RS-14-100

Quad Cities Nuclear Power Station, Units 1 and 2
Renewed Facility Operating License Nos. DPR-29 and DPR-30
NRC Docket Nos. 50-254 and 50-265

Subject: Additional Information Regarding License Amendment Request Associated with Use of Neutron Absorbing Inserts in Spent Fuel Pool Storage Racks

ATTACHMENT 1
Response to Request for Additional Information

**QCNPS Composite Areal Density Coupon Results
Based Upon Minimum As-Measured Coupon Values**

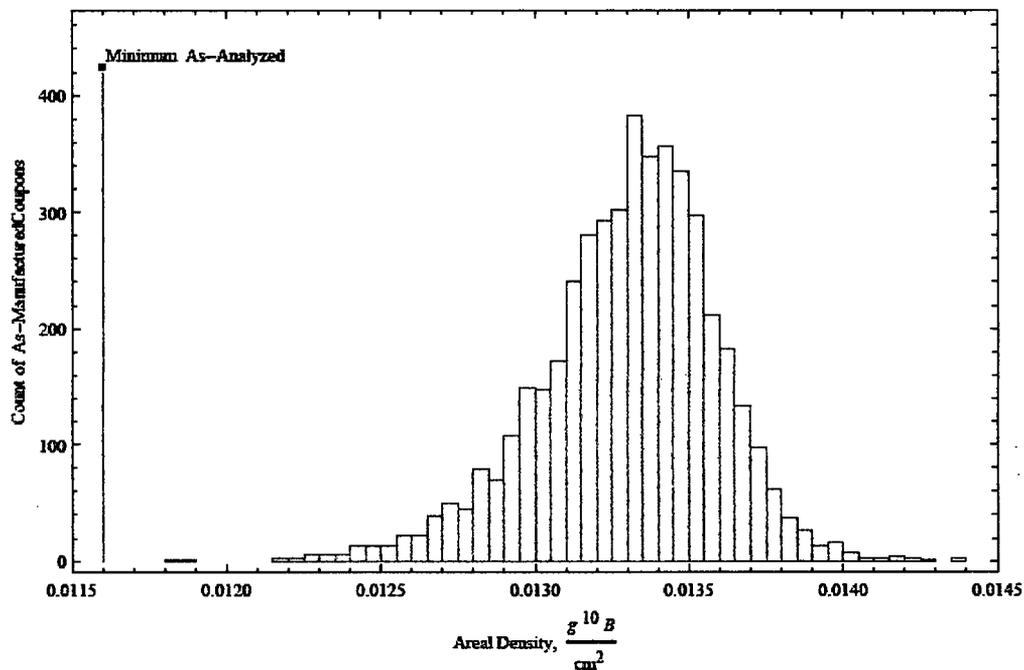
For the 'Super Lattice' cases there is very little margin to the regulatory limit. Section 3.4.2 of Attachment 1 to the July 16, 2013 letter, discusses mechanical wear of the inserts. While the section indicates that minimal insert mechanical wear is expected the minimum as-built areal density of the inserts is the same value as is being used in the NCS. This means that for the inserts which are installed at the minimum as-built areal densities can tolerate essentially no wear of any kind before the insert no longer has the requisite areal density to perform as analyzed. With that in mind provide the following:

- a. Justification of the proposed wear surveillance. NRC staff considers one insert too limited of a sample size and recommends the licensee increase the sample size to three or more. Additionally, the NRC staff considers the licensee's proposed definition of 'high duty' to be limited as it does not appear to consider the potential for a low number of fuel

movements having a higher contact with the insert as being more limiting than a high number of fuel moves with essentially no contact with the insert.

- b. Discuss whether the process of placing the inserts into the rack results in any wear on the insert.

To date, through general observation, there has been no evidence of any uniform mechanical wear on the NETCO-SNAP-IN[®] inserts at either Peach Bottom Atomic Power Station or LaSalle County Station. If wear were to occur, areal density coupon test results performed for each insert show that significant margin exists to the minimum certified areal density of the inserts.

The histogram below shows the minimum measured areal density values of a quantity of approximately 3,250 test coupons (i.e., one coupon for every sheet, from which two inserts are made) representing inserts manufactured for QCNPS to date.

These results are based upon the minimum measured values of the insert coupons that were cut from the same sheet of material as the inserts. This histogram shows that the minimum certified areal density value, which is labeled on the histogram as "Minimum As-Analyzed," is six sigma less than the average minimum measured areal density of the manufactured inserts. This provides considerable margin sufficient to identify wear phenomena that may occur on the inserts before it would affect their intended reactivity hold-down capability.
